**DATE:** April 5, 2018  
**TO:** San Francisco Planning Commission  
**FROM:** Jessica Range, Planning Department  
Elizabeth White, Planning Department  
**RE:** Environmental Impact Report for Case No. 2011.1356E-Central SoMa Plan  
**HEARING DATE:** April 12, 2018

## DRAFT Planning Commission Motion NO. M-XXXXX

DATE: April 5, 2018  
TO: Planning Commission  
FROM: Elizabeth White and Jessica Range, Environmental Planning  
RE: Errata to the Environmental Impact Report for the  
Central South of Market (SoMa) Area Plan  
Planning Department Case No. 2011.1356E

**Figure RTC-1**  
Existing, Proposed, and Revised Height and Bulk Map for Block 3762

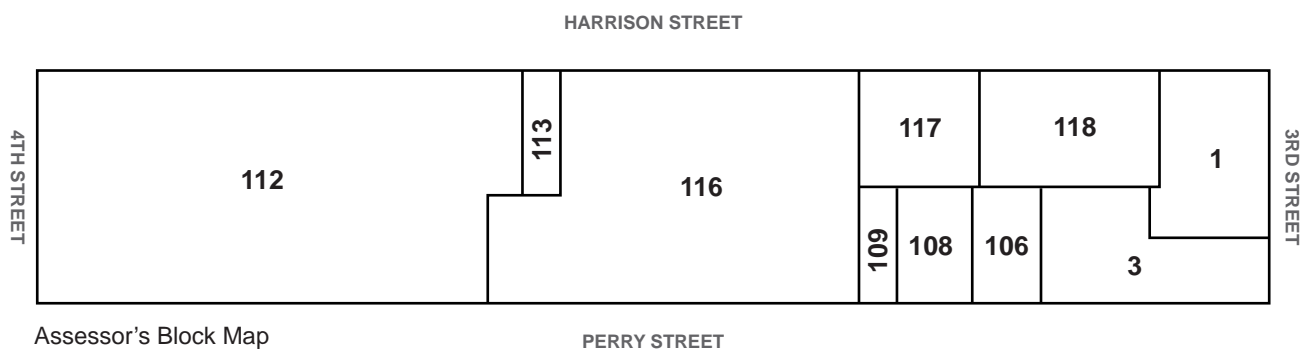
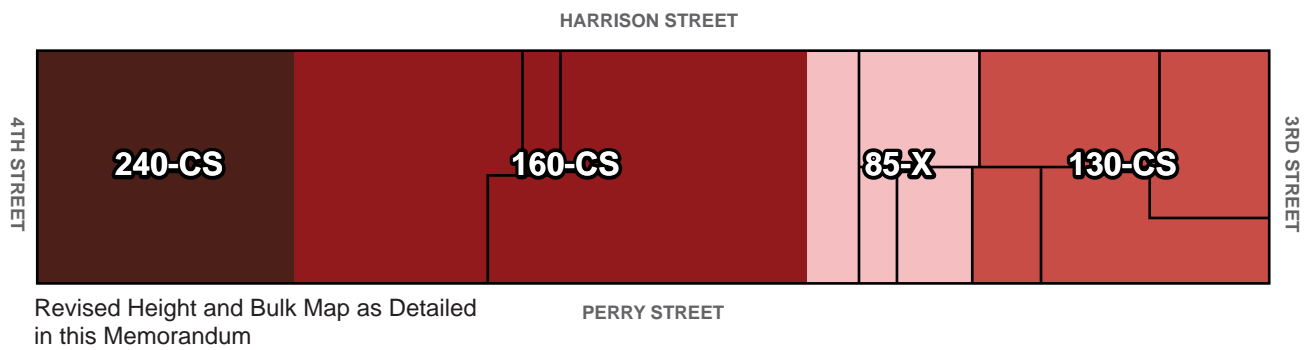
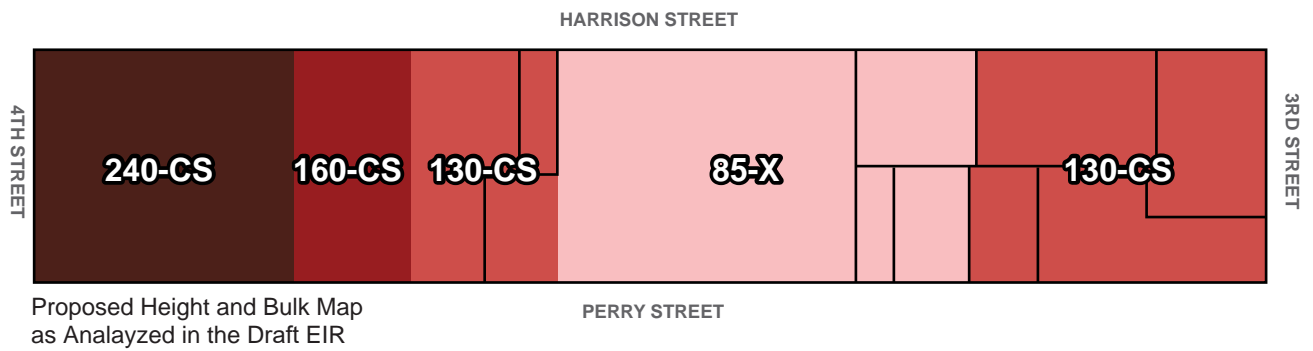
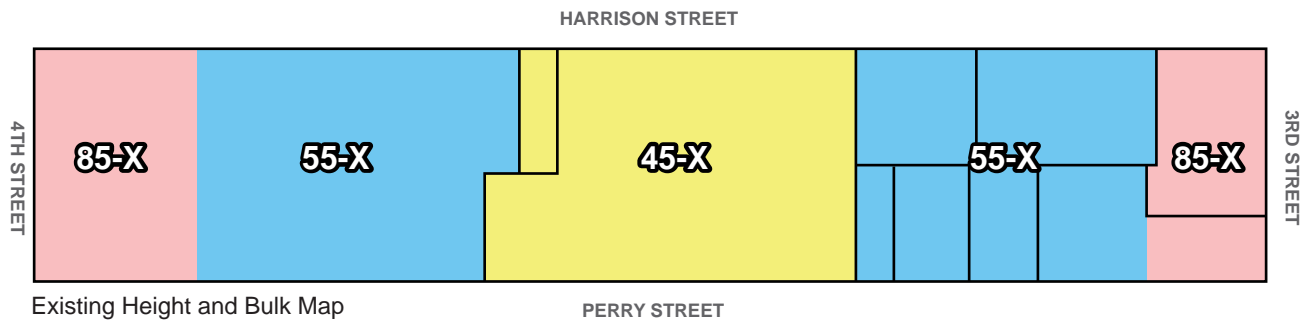
The Planning Department proposes to alter the proposed Height and Bulk Map from that analyzed in the Draft EIR for a portion of the block bounded by Harrison, Third, Bryant, and Fourth streets.<sup>4</sup> Specifically, the proposal entails extending a 160-CS Height and Bulk District to encompass most of the mid-block area including the eastern half of Lot 112 and all of Lots 113 and 116 within Block 3762. The Draft EIR evaluated the western portion of this mid-block change as a 130-CS Height and Bulk District and the eastern portion as an 85-X Height and Bulk District. See **Figure RTC-1, Existing, Proposed, and Revised Height and Bulk Map for Block 3762**, which depicts the existing height of the block, the proposed heights analyzed in the Draft EIR, and the revised heights now proposed. Draft EIR **Figure II-7, Proposed Plan Area Height and Bulk Districts [Revised]**, and **Figure II-8, Generalized Height Limits, Existing and Proposed Height and Bulk Districts [Revised]**, are also revised to show the changes.

Based on the foregoing, the revisions to the Draft EIR Height and Bulk Map (Draft EIR Figure II-7, p. II-19) would not result in any new or substantially more-severe significant aesthetic impacts than identified in the Draft EIR.

**Figure RTC-2**  
Wind Tunnel Test Points Near Block 3762

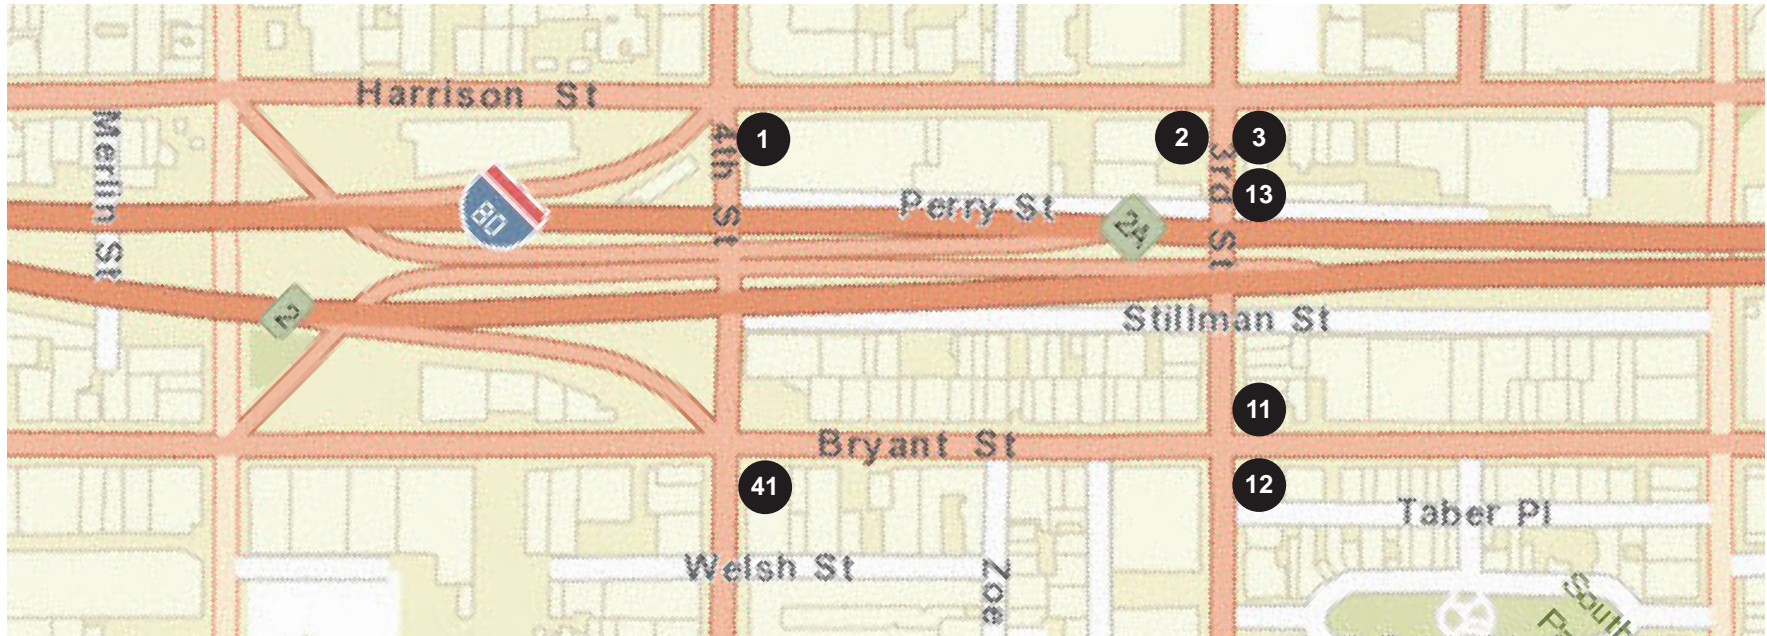
Programmatic wind-tunnel testing for the Draft EIR was undertaken at the Plan level, based on the same building masses as evaluated in the visual simulations, including the revised simulations presented in this RTC document.<sup>7</sup> In the vicinity of the proposed changes to the Height and Bulk Map, wind test points were located at the following seven locations<sup>8</sup> (see **Figure RTC-2, Wind Tunnel Test Points near Block 3762**):

- The southeast corner of Fourth and Harrison streets (at the base of the aforementioned proposed 240-foot-tall tower), Test Point 1;
- The southwest and southeast corners of Third and Harrison streets, Test Points 2 and 3, respectively;
- The northeast and southeast corners of Third and Bryant streets, Test Points 11 and 12, respectively;
- The southeast corner of Third and Perry streets, Test Point 13; and
- The southeast corner of Fourth and Bryant streets, Test Point 41.

No test points were immediately adjacent to the Harrison Street frontage where the Height and Bulk Map changes are proposed; the closest points are those at Fourth and Harrison and at Third and Harrison streets. Existing conditions at the seven test points noted above are moderately windy, with the wind speed that is exceeded 10 percent of the time, or wind comfort speed, ranging from 6 miles per hour (mph) to 19 mph.<sup>9</sup> (In general, conditions in SoMa are less windy than in very windy locations in San Francisco, such as the Van Ness and Market area.) Of the seven test points, the Draft EIR wind-tunnel testing found that Plan Area development would alter the wind comfort speed by 1 to 5 mph. Wind speed would decrease at five of the seven points and would increase at two locations—the southwest and southeast corners of Third and Harrison streets—by 3 mph. Wind speeds do not currently exceed the Planning Code's hazard criterion of 26 mph for one full hour of the year at any of the seven locations under existing conditions and would not do so under conditions with Plan development.

Based on the foregoing, the revisions to the Draft EIR Height and Bulk Map (Draft EIR Figure II-7, p. II-19) would not result in any new or substantially more-severe significant wind impacts than identified in the Draft EIR.

**Figure RTC-3**

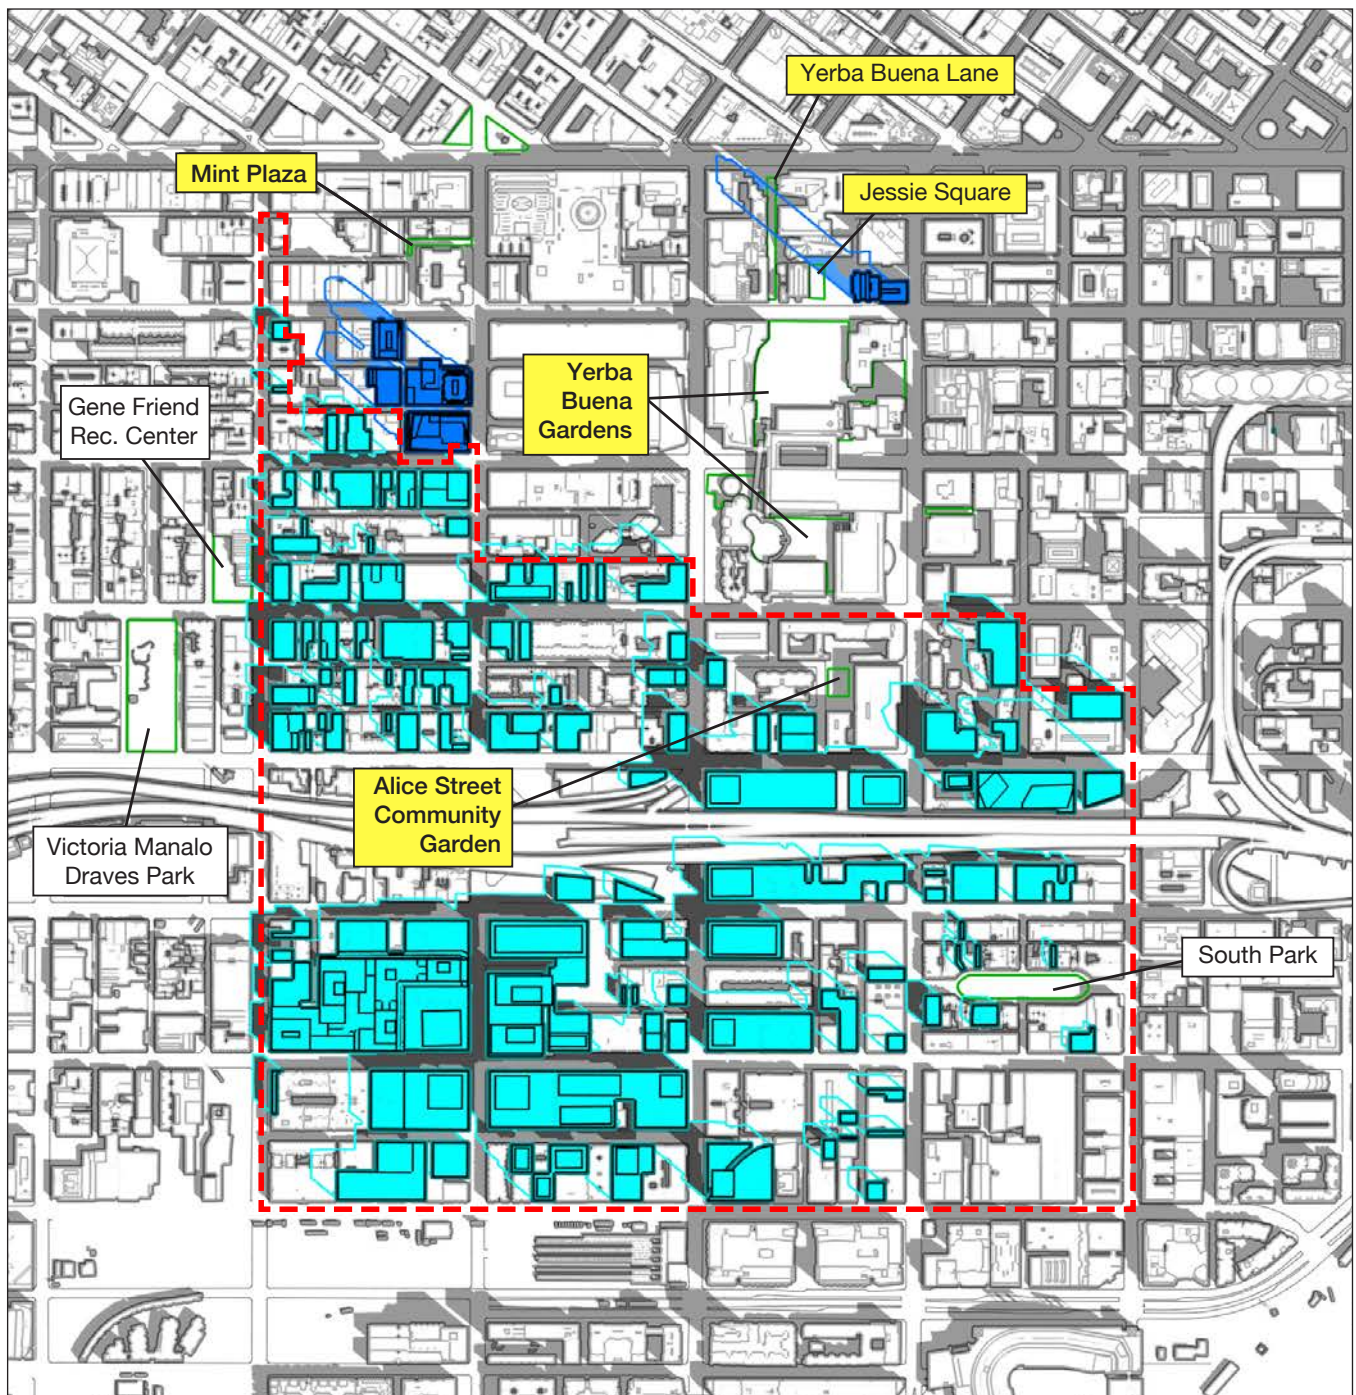
Comparison Between Draft EIR Shadow and Potential New Shadow, Alice Street Community Garden, December 20, 10 a.m.

Based on the foregoing, the revisions to the Draft EIR Height and Bulk Map (Draft EIR Figure II-7, p. II-19) would not result in any new or substantially more-severe significant shadow impacts than identified in the Draft EIR.

**Figure II-7**  
 Proposed Plan Area Height and Bulk Districts [Revised]

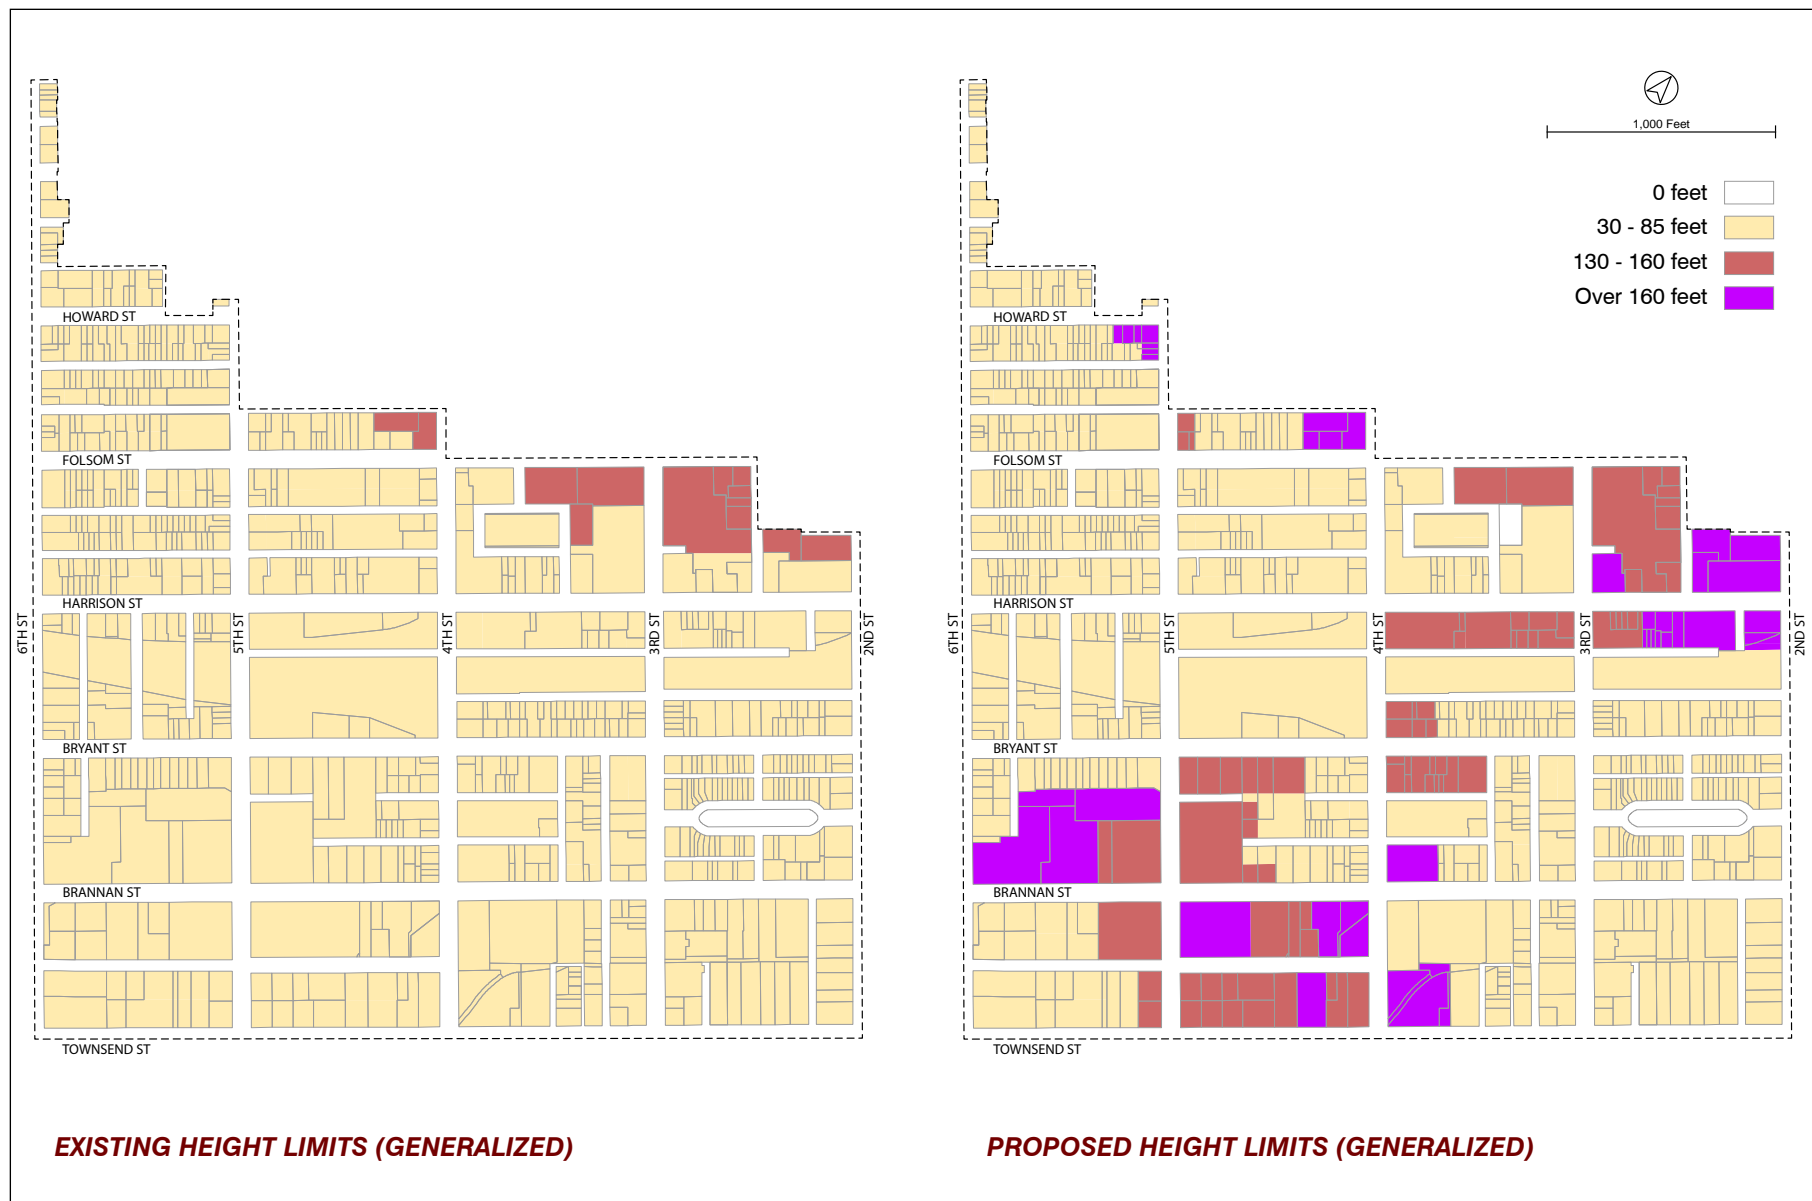
“However, elsewhere in the DEIR, this intensity of development for the Project site appears not to be properly analyzed. For example, the proposed height map at Figure II-7 of the DEIR shows a proposed height limit of 250 feet for the property, not 350 feet. Height limits of 400 feet and 300 feet are proposed on sites on which residential towers are proposed immediately adjacent to the Project site. A 250-foot height limit on a 17,406 square foot site cannot accommodate anything close to the 427 units that the DEIR states was analyzed in the Plan DEIR.

“Moreover, any such analysis will establish that there is no significant difference in terms of environmental impacts between 250 feet (the height limit indicated in Figure II-7) and at least 350 feet (the proposed height for the Project as described on page IV-8) and will not change the conclusions of the DEIR.

Page:	Comment:
III-10	<u>Urban Design Element:</u> Text provides that “In addition, several parcels north of the I-80 freeway and east of Fourth Street would be zoned to a maximum of 300-feet.” This should be changed to 350 feet, to be consistent with the proposed height increase map in Figure II-7.

- Height limits for several parcels, as shown in Figure II-7 on p. II-19, are higher than those proposed in the ~~2016~~2018 draft Central SoMa Plan. These include the following locations:

- \* On Draft EIR p. II-10, Figure II-3, Proposed Plan Area Use Districts, has been revised to reflect the change from MUO to CMUO zoning districts.
- \* On Draft EIR p. II-19, Figure II-7, Proposed Plan Area Height and Bulk Districts, has been revised to show the revised heights now proposed.
- \* On Draft EIR p. II-20, Figure II-8, Generalized Height Limits, Existing and Proposed Height and Bulk Districts, has been revised to show the revised heights now proposed.
- \* On Draft EIR p. II-22, the fifth and sixth sentences of the first paragraph of text beneath the bullet list on Draft EIR p. II-22 have been revised as follows to clarify that certain height limits less than 200 feet would apply to portions of the Plan Area and not to specific building sites:
